REQUEST FOR INFORMATION

PROJECT: UOG IFB-23-01	RFI NO.	1
------------------------	---------	---

Subject: **RFI for the list of Item** Date: **June 29, 2023**

School of Health - Nursing Annex
EDA Project No. 0779-07657 UOG Scientific Education and Research Facilities
Mangilao, Guam
OWNER: UNIVERSITY OF GUAM
SHEET TITLE: **SITE ELECTRICAL PLAN SECTION A & B - NURSING BUILDING ANNEX**

2ES101

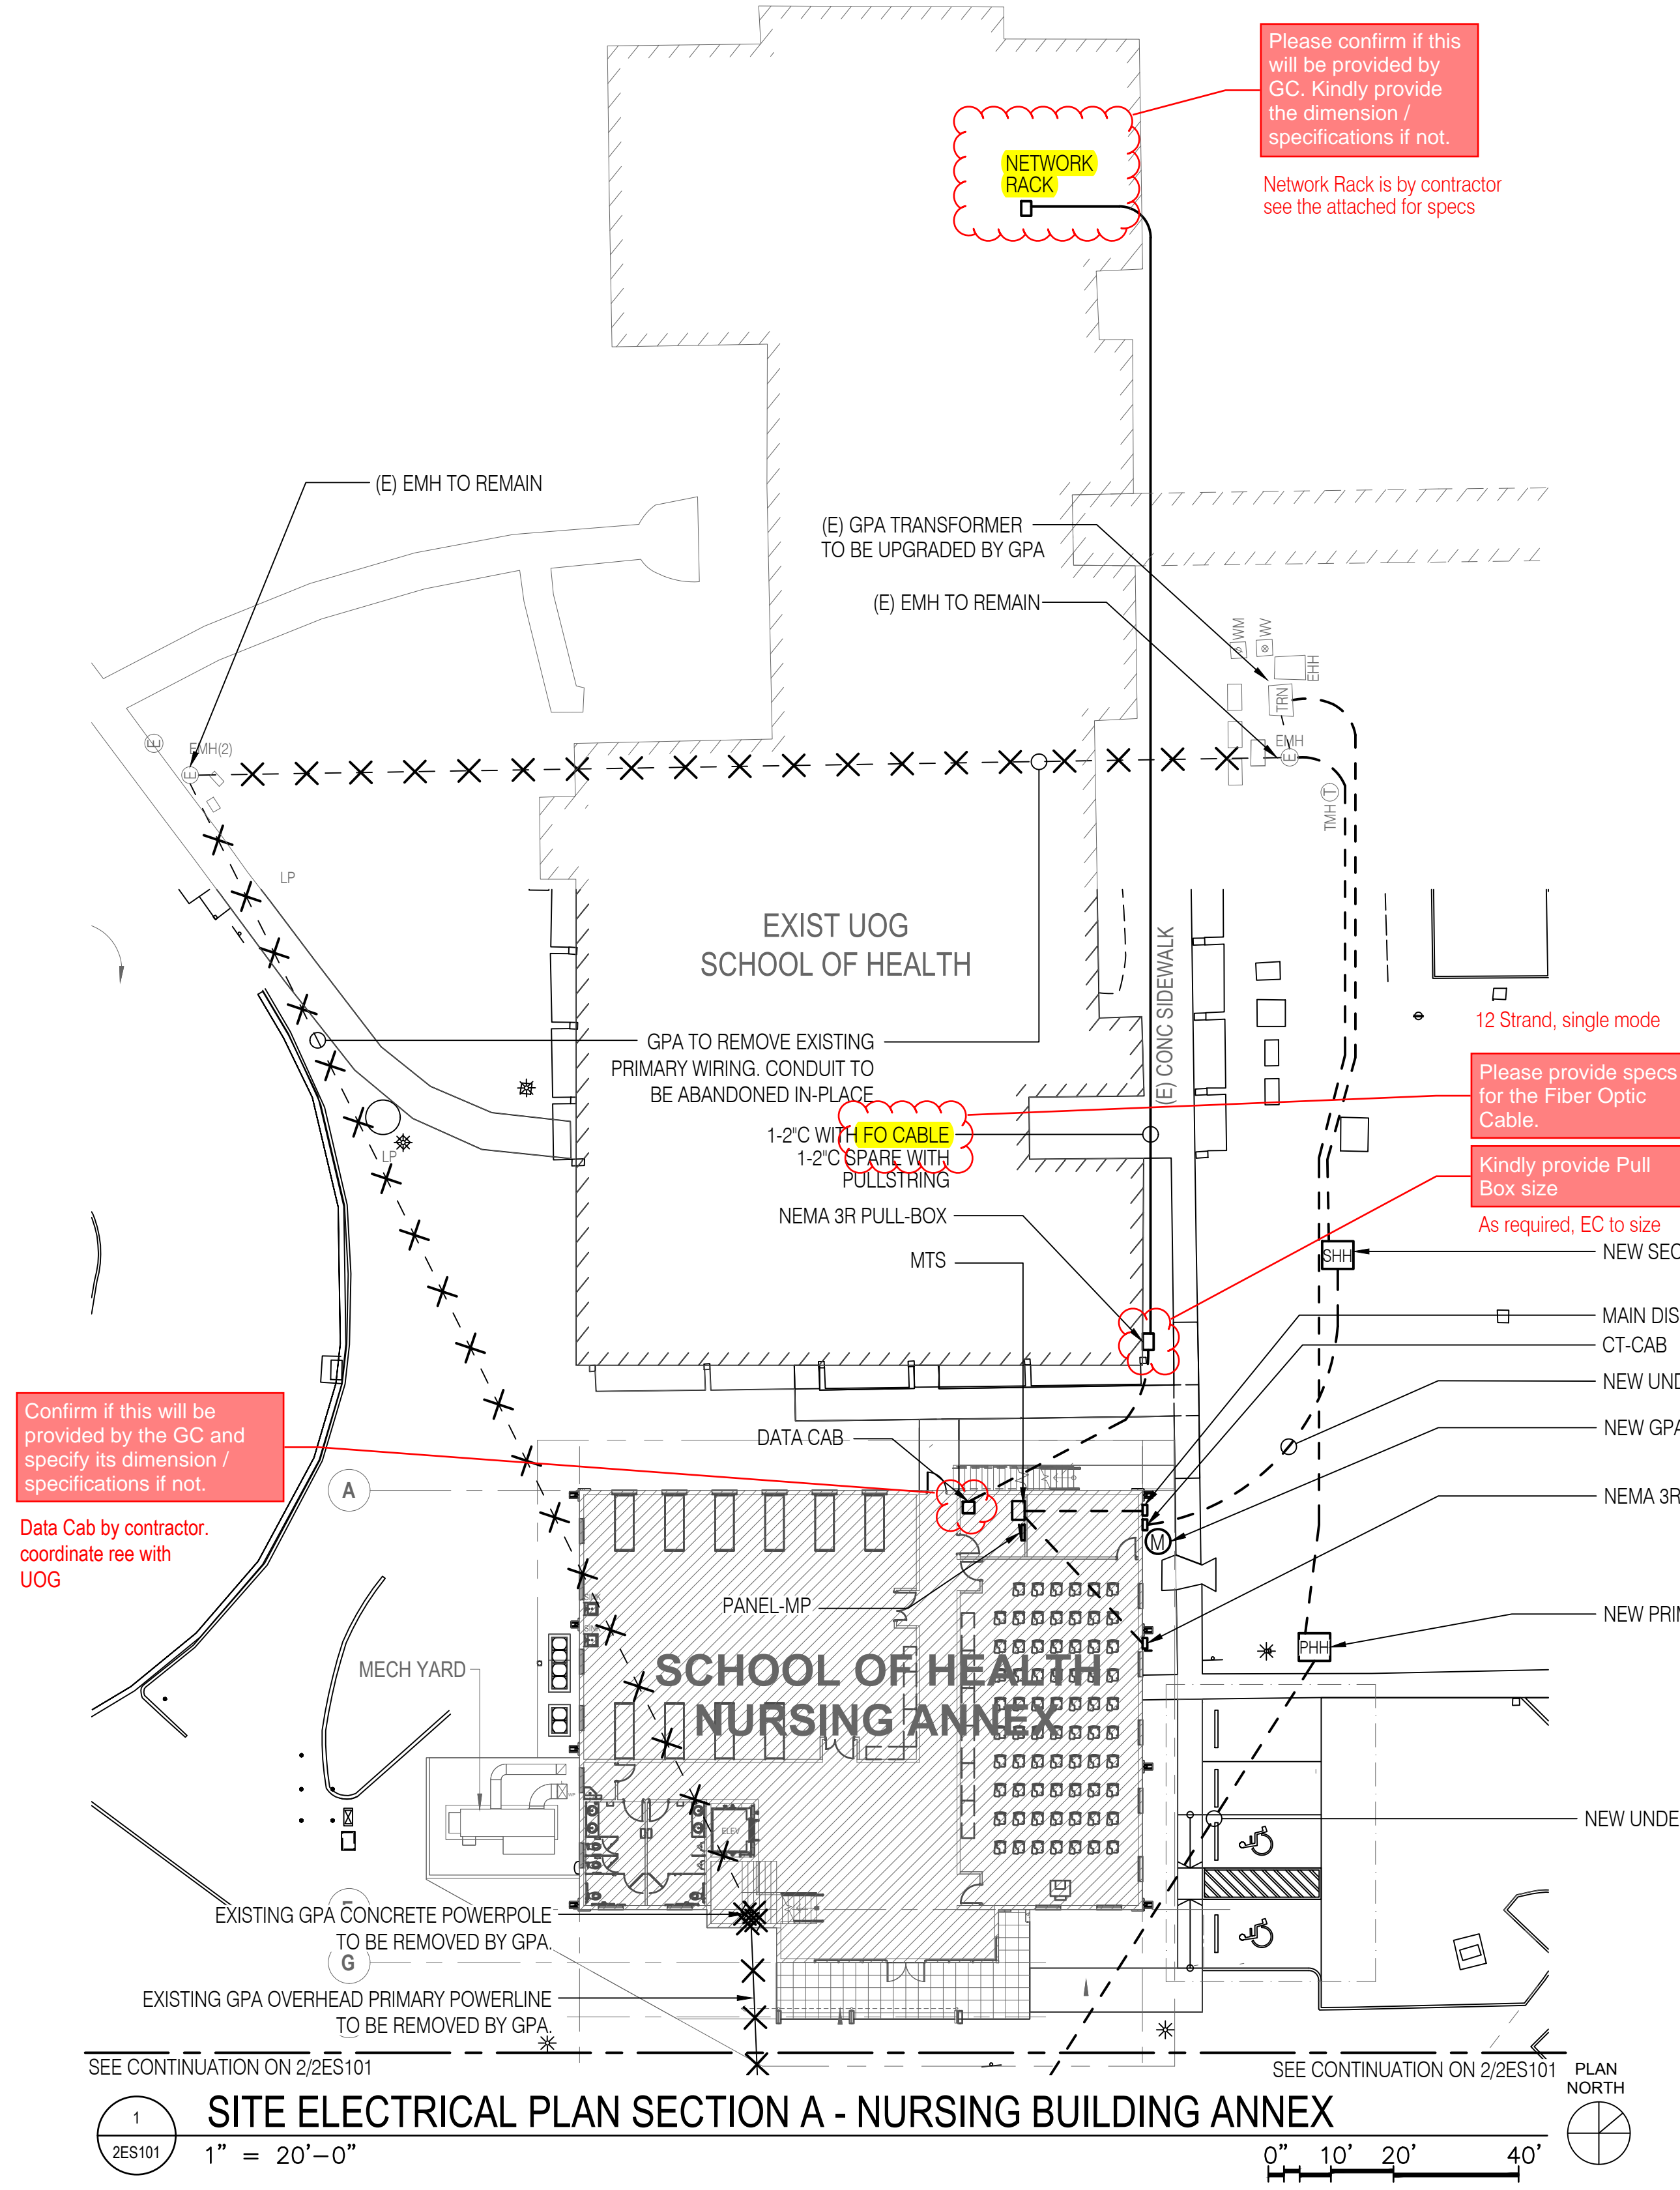
- 12 Strand, single mode
- Please provide specs for the Fiber Optic Cable.
- Kindly provide Pull Box size
- As required, EC to size
- NEW SECONDARY HANDHOLE, SEE 2/E501
- MAIN DISCONNECT
- CT-CAB
- NEW UNDERGROUND SECONDARY POWERLINE
- NEW GPA METER
- NEMA 3R DISCONNECT/PLUG FOR GENERATOR CONNECTION
- NEW PRIMARY HANDHOLE, SEE 1/E501
- NEW UNDERGROUND PRIMARY POWERLINE

1 FIRST FLOOR POWER PLAN
 2EP101 1/8" = 1'-0"

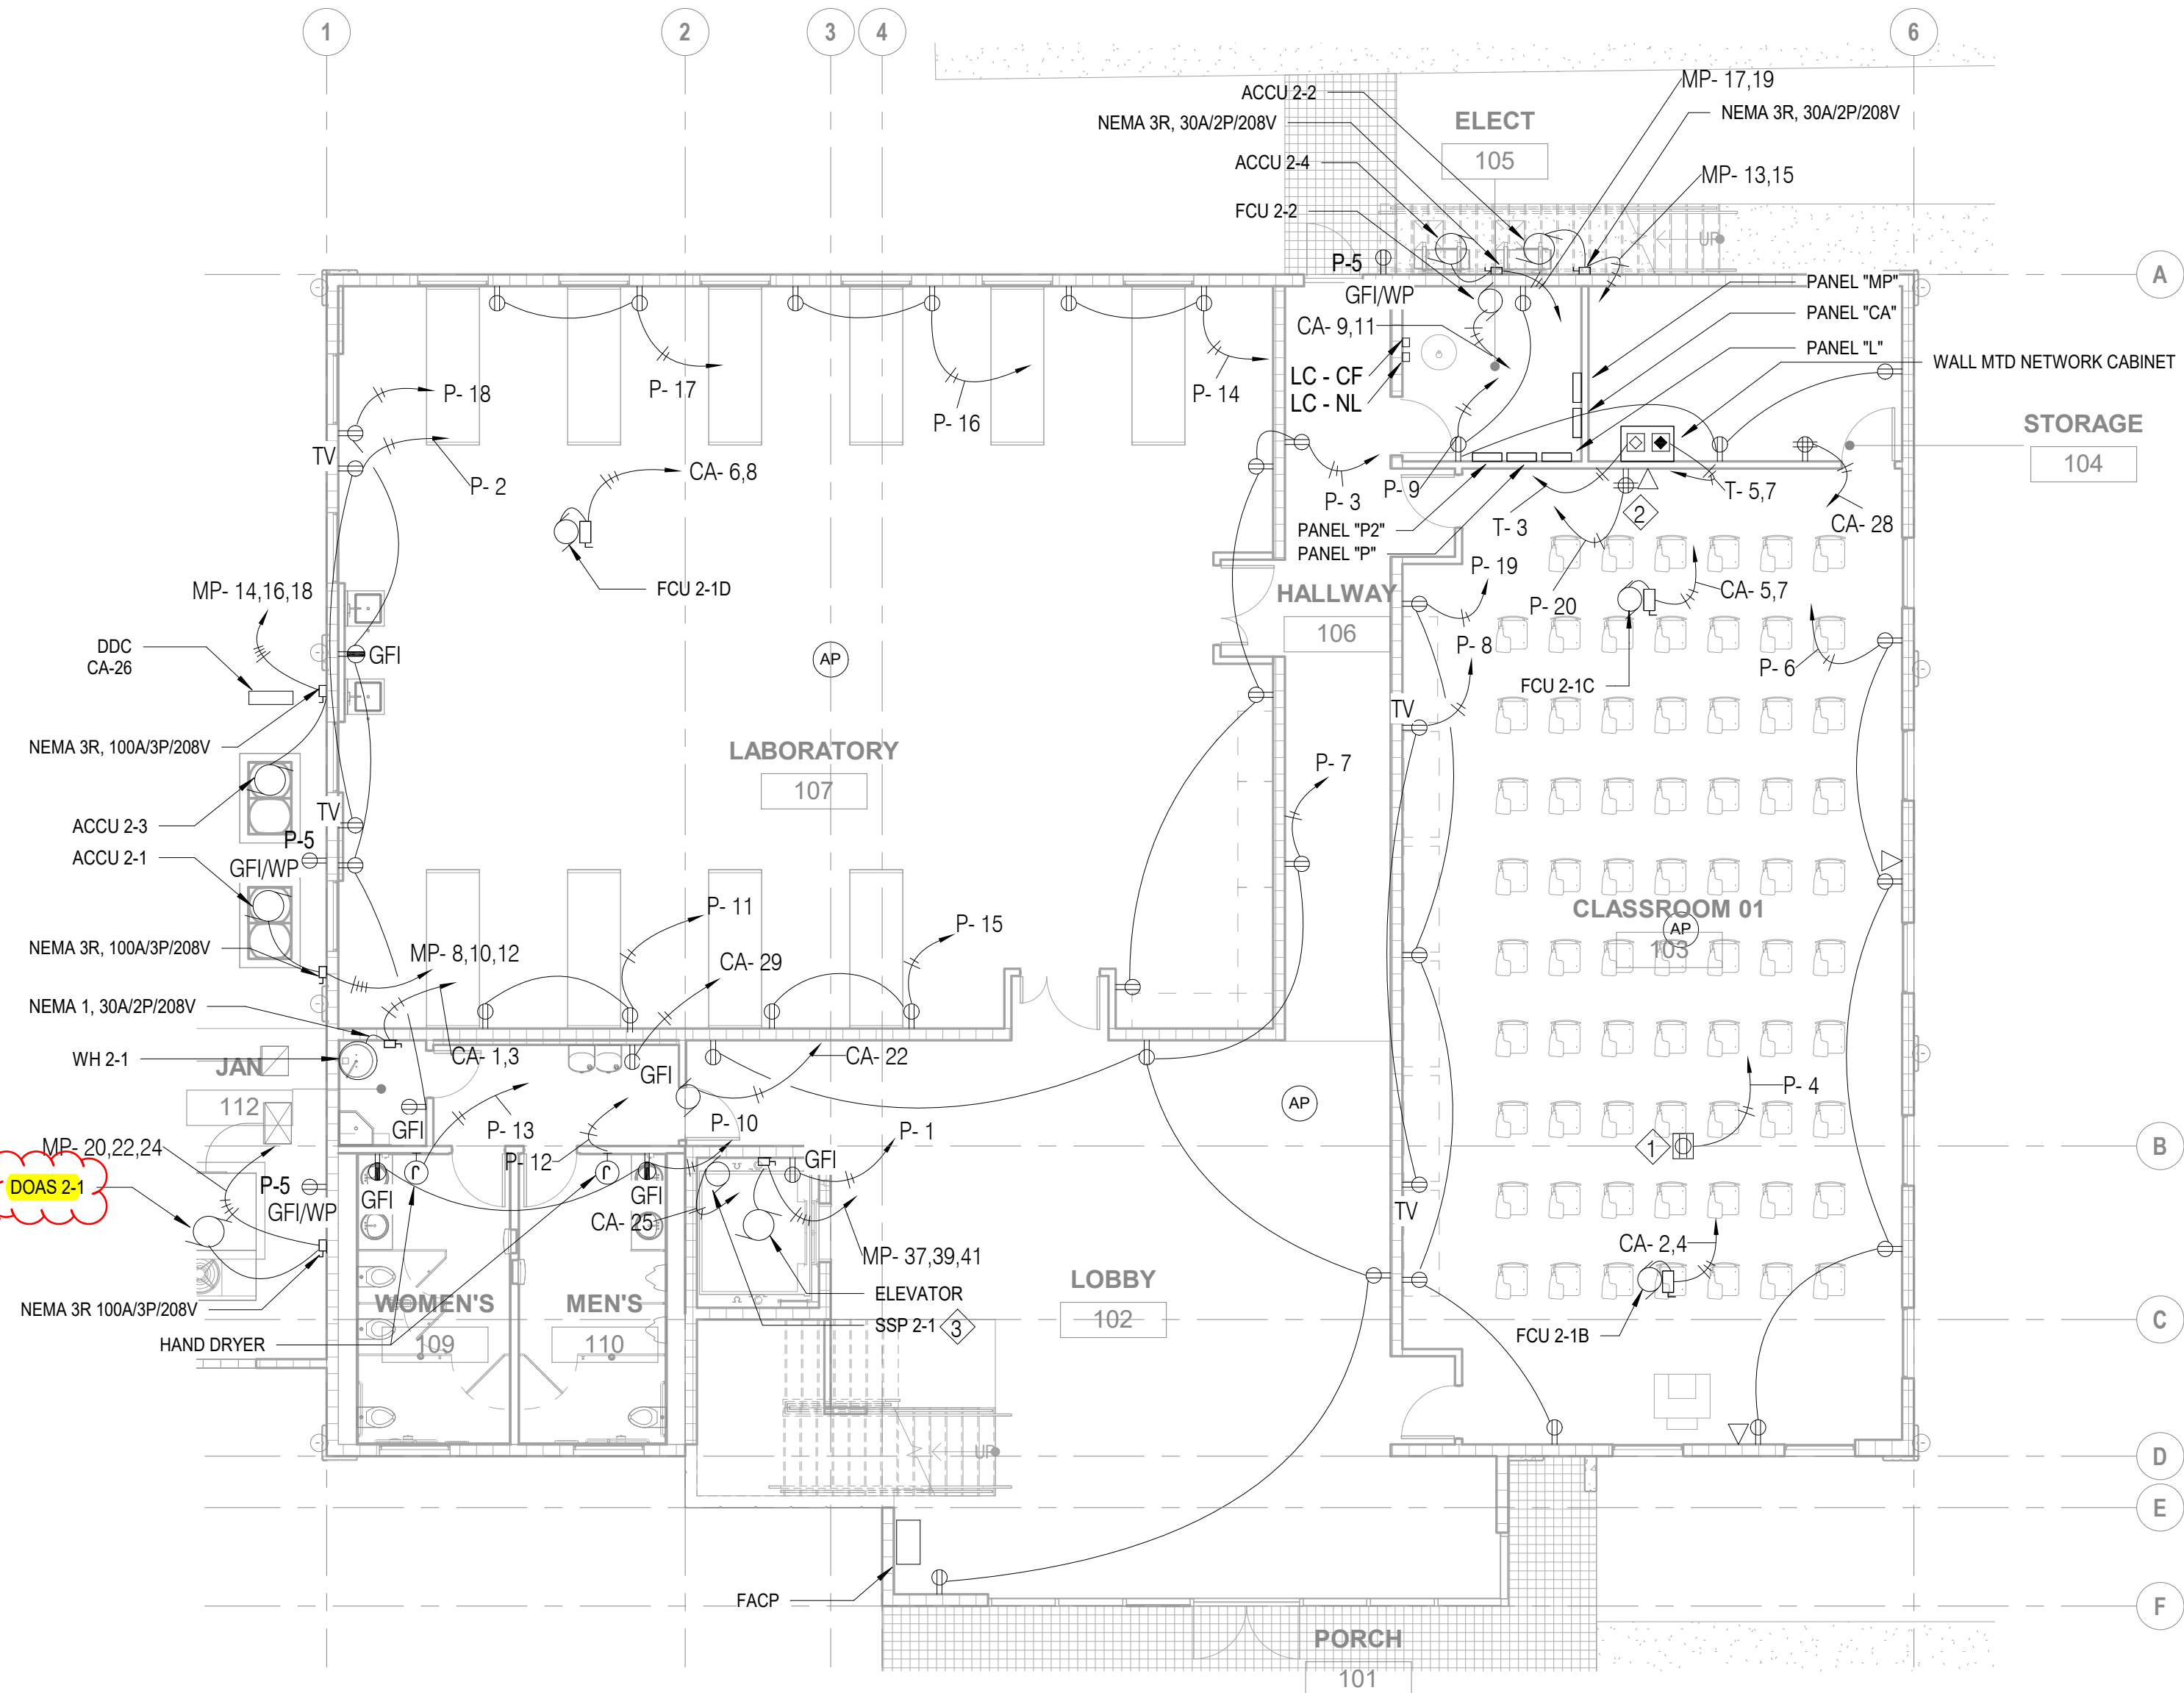
Confirm if this is DOAS 2-3 as indicated on the Schedule of Loads for Panel "MP"
 Per Mechanical plans, DOAS 2-1 is correct
